TECHNICAL SERVICE BULLETIN

Technical Service Bulletin: 502-1357

TECHNICAL SERVICE BULLETIN 502-1357 REMEDY INSTRUCTIONS

Make(s): TANDARA Model(s): MANY, SEE BELOW Model Year(s): 2021	Repair Code: SB-665-03-00-004069 Allotted Time: 1.50 HRS Inspection Code: SB-665-05-00-004068 Allotted Time: .20 HRS
	Concern: The upper mount(s) for the jack leg(s) may bend allowing the jack(s) to put the cross-shaft and motor into a bind, which will not allow an operator to retract or extend the landing legs of the vehicle.	Photo(s) Required: YES, EACH SIDE Prior Authorization Required: YES Part(s) Number: F100272150 Part(s) Return: N/A

FIG. 1

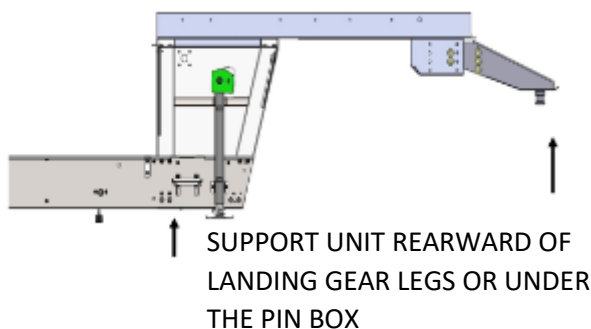
STEP 1: SUPPORT THE FRONT OF THE UNIT REMOVING THE LOAD FROM THE LANDING GEAR LEGS (FIG. 1);

FIG. 2

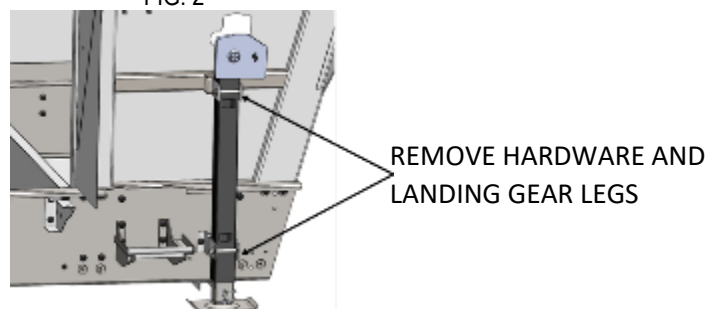
STEP 2: USING A 9/16" SOCKET OR WRENCH, REMOVE THE TWO 3/8" CARRIAGE BOLTS THAT HOLD THE LANDING GEAR LEG IN PLACE AND REMOVE THE LEG FROM THE MOUNTING BRACKETS (FIG. 2);

FIG. 3

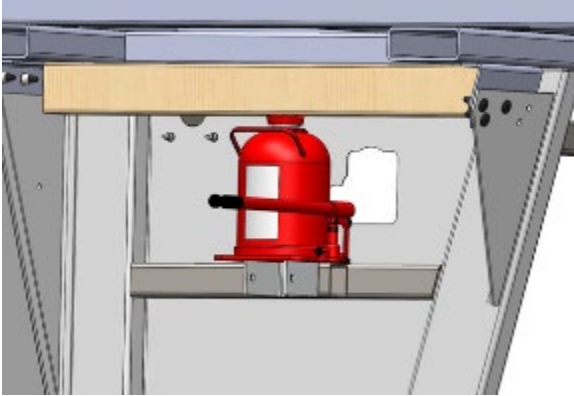
STEP 3: PLACE A BOTTLE JACK DIRECTLY ON TOP OF THE MOUNTING BRACKET. PUSHING AGAINST THE FRAME MEMBER ABOVE THE BRACKET, USE THE BOTTLE JACK TO STRAIGHTEN THE TUBE THAT THE BRACKET IS WELDED TO (FIG. 3);

NOTE: USE A PIECE OF WOOD OR STEEL TO SPREAD THE LOAD ON THE FRAME MEMBER THAT THE JACK IS PUSHING AGAINST, SO THE BOTTLE JACK DOES NOT DAMAGE THE STEEL TUBING.

FIGURE 4

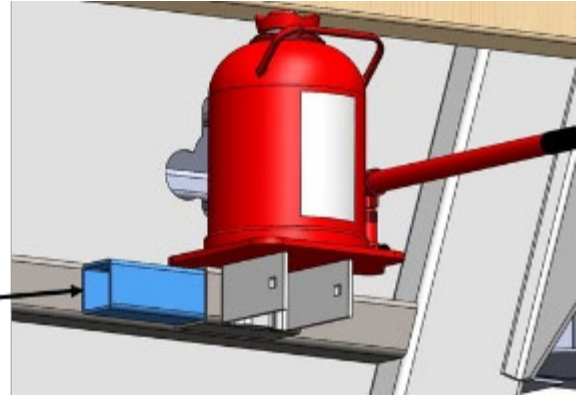
STEP 4: INSERT THE PROVIDED 1.75" X 1.75" TUBE INTO THE EXISTING 2"X 2" TUBE (FIG. 4);

STEP 5: RELEASE THE PRESSURE FROM THE BOTTLE JACK (FIG. 4);

INSERT TUBE

FIG. 5

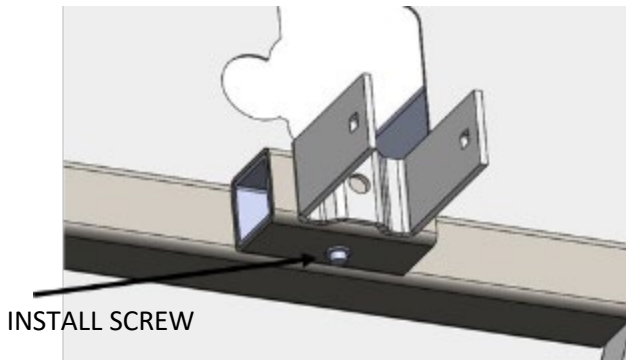
STEP 6: RUN THE PROVIDED SELF-TAPPING SCREW THROUGH BOTH TUBES TO HOLD THE INSERTED TUBE IN PLACE (FIG. 5);
